## Staff Report

Title: Lyndon Oaks Planned Unit Development (ZMA-2-23)

Date: May 16, 2024

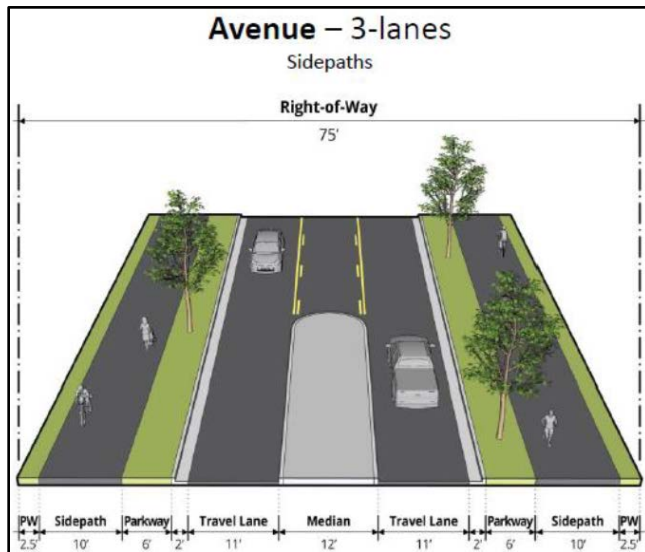
**Staff Analysis:** The available locations to add additional on-street parking spaces are limited based upon housing type design and layout (unable to provide on-street parking when front-loaded houses are present) and the presence of the Duke Energy powerline easement bisecting the road. The five additional on-street parking spaces bring this road into greater compliance with the UDO and provide additional parking options for residents along this road.

*Applicant Response: Five on-street parking spaces have been added to Road I.*

May 16, 2024 Proposed Cross-Section

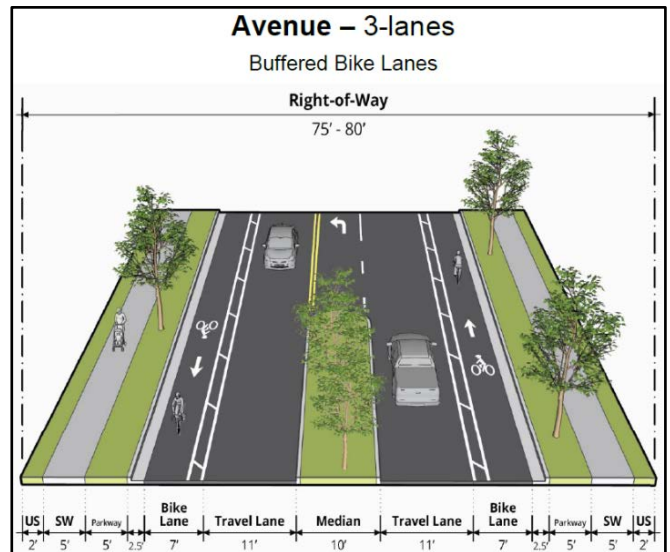
**Staff Recommendation (April 18, 2024):** Throughout the Master Plan review, staff informed the Applicant that the Comprehensive Transportation Plan (CTP) and UDO do not call for a sidepath along this portion of the Widewaters Parkway Extension, and therefore, the Avenue – Sidepaths Cross-Section should not be constructed. Instead, it is staff’s recommendation to construct the Avenue – Buffered Bike Lane Cross-Section and explore the option of expanding the right-of-way from 75 feet to 80 feet to account for a ten-foot-wide sidepath on one side of the street.

**Applicant Response:** The proposed roadway cross-section for Widewaters Parkway and site design has been modified to comply with the CTP, UDO, and staff recommendations.

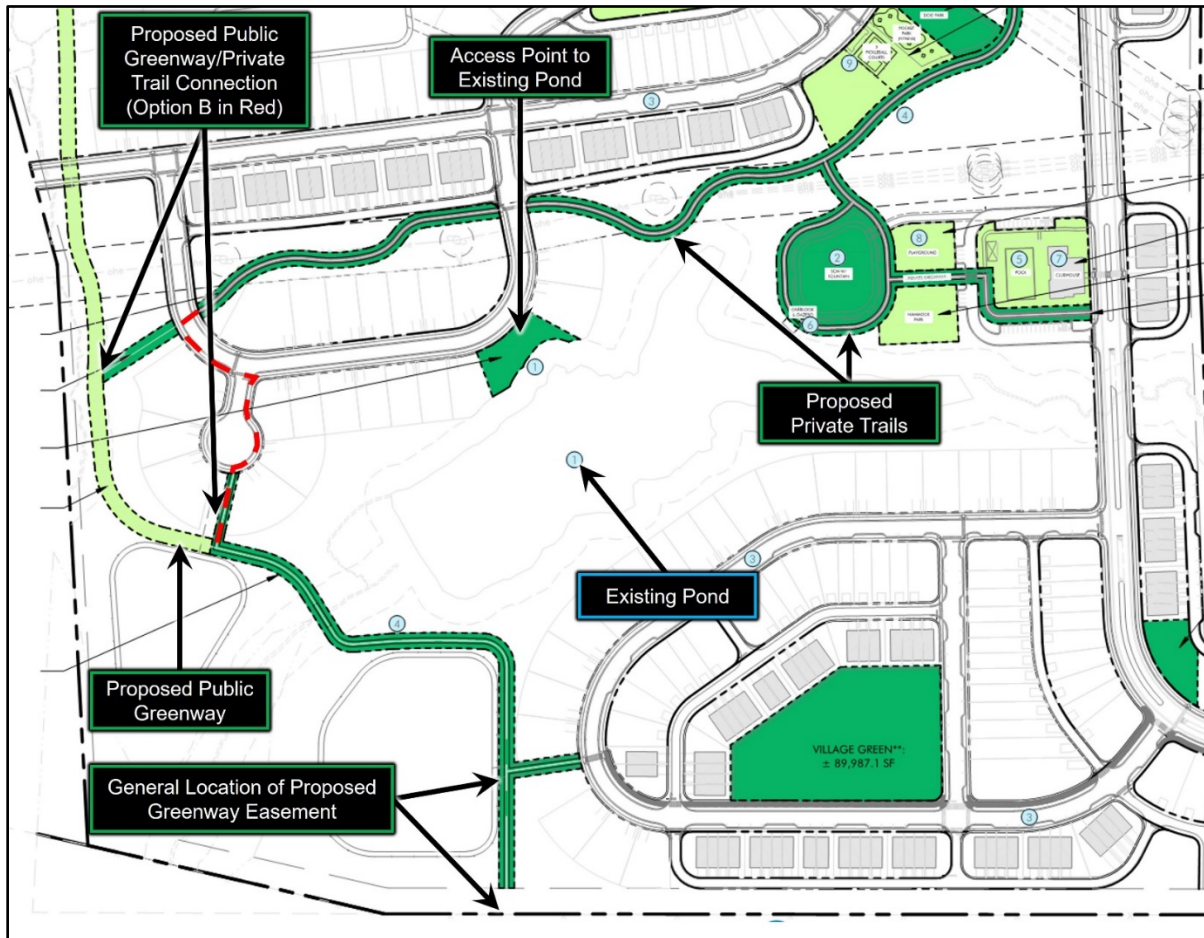
**Staff Analysis (April 18, 2024):** To increase pedestrian connectivity throughout the site, staff encourages the Applicant to continue to explore the feasibility of connecting the private trail network to the public trail network through the powerline easement that runs east to west along the middle of the site. Staff also encourages the Applicant to continue to explore the feasibility of adding a trail around the existing pond towards the south-central portion of the site.

**Applicant Response:** The private trail network has been revised to extend through the powerline easement and connect to the proposed public greenway trail in the general location shown on the above graphic. The revised Master Plan also provides an Option B route (similar to the requested optionality for the public greenway corridor described on Page 17 of this Staff Report) for this private/public trail connection for consideration in case the environmental permitting through the United States Army Corps of Engineers (USACE) is not achievable based upon the developer's cumulative stream and wetland impacts across the entire site. A formal paved trail around the existing pond presents challenges in terms of environmental impacts and potential negative effects to the existing pond's stability. In lieu of a formal paved trail, the Applicant revised the Master Plan to include a passive open space area near the northwest portion of the pond so residents can still access the pond and enjoy its natural beauty (see above graphic).

*Staff Analysis: The revised private trail network increases pedestrian connectivity through the site and allows residents to join the public greenway trail via a more natural setting rather than using a roadside sidewalk. Staff support this public/private trail connection as it has been proposed to implement the recently adopted Transportation related Zoning Text Amendment (ZTA-1-24). Staff also support the request for optionality but will continue to encourage the Applicant to prioritize the construction of Option A for both the public and private trail networks. In terms of the paved trail around the existing pond, the Applicant indicated that additional informal access points can be provided at select areas (in addition to the passive open space area to the northwest) so residents can still embrace the natural beauty of the pond in the absence of a formal, paved trail. Staff support these informal access points because it is an opportunity to balance environmental protection (selective clearing per USACE regulations) with amenitizing an existing natural feature for the benefit of the community. Staff recommend these informal access points are identified on the Master Plan.*

April 18, 2024 Proposed Design

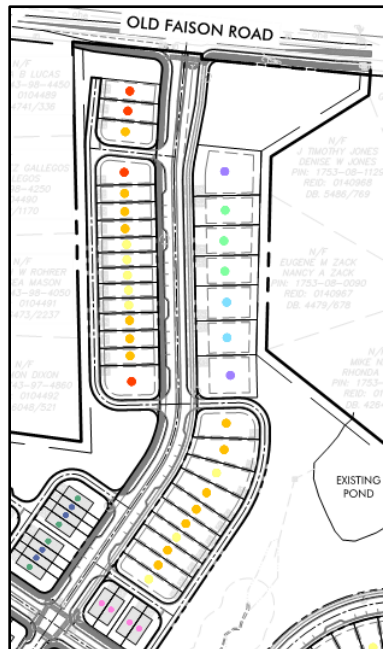
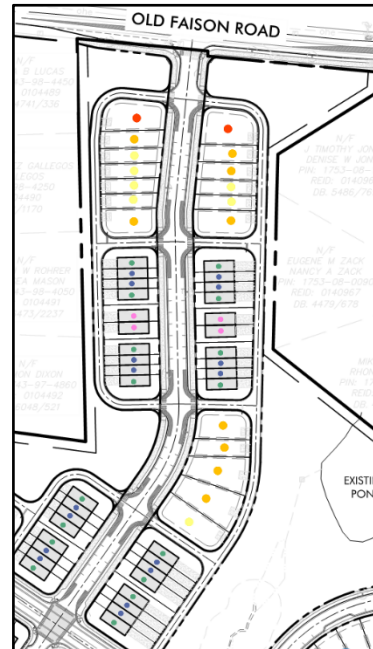
- Requested:** The Applicant proposes a modified Main Street Cross-Section for the development’s access drive (currently known as Tart Farm Road). The proposed design of this road meets the standards outlined in Section 7.2.A.2 of the UDO, except for the landscaped median. The Applicant proposes to remove this required median so that driveway and alley access are not restricted.

*Applicant Response: The design of this portion of the neighborhood has been revised to propose rear-loaded housing products rather than front- and rear-loaded housing products. The roadway design has also been revised to implement the Urban Main Street – Wide Sidewalk Cross-Section.*

**Staff Analysis:** *Staff support the proposed revisions to this roadway as they eliminate several driveway curb cuts along a main entrance to the neighborhood that could have created unsafe conditions. In addition, the change to all rear-loaded housing products and roadway design present an opportunity to provide a high-quality streetscape with landscaping, hardscaping, and fencing.*

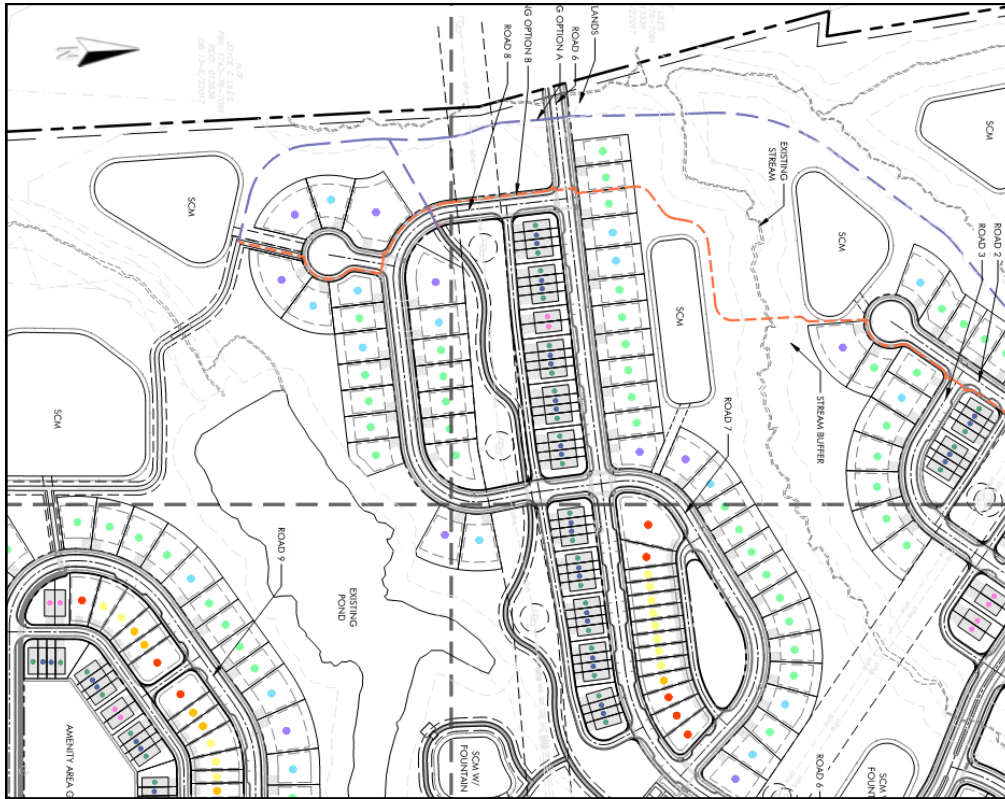
***Staff Analysis (April 18, 2024): Staff understand that there are environmentally sensitive areas along the western side of the site that present challenges for connecting the north, central, and southern pods of the development together via a street. Staff encourages the Applicant to continue to look for ways to increase connectivity and reduce the number of dead-end roads or cul-de-sacs.***

***Applicant Response: The Applicant revised the Master Plan to remove all dead-end roads, except for the three alleys near the southeast portion of the site (area where townhomes are proposed to front open spaces). The revised Master Plan still includes two cul-de-sacs in the northern and central portions of the site, which are shown on the following page of this Staff Report.***
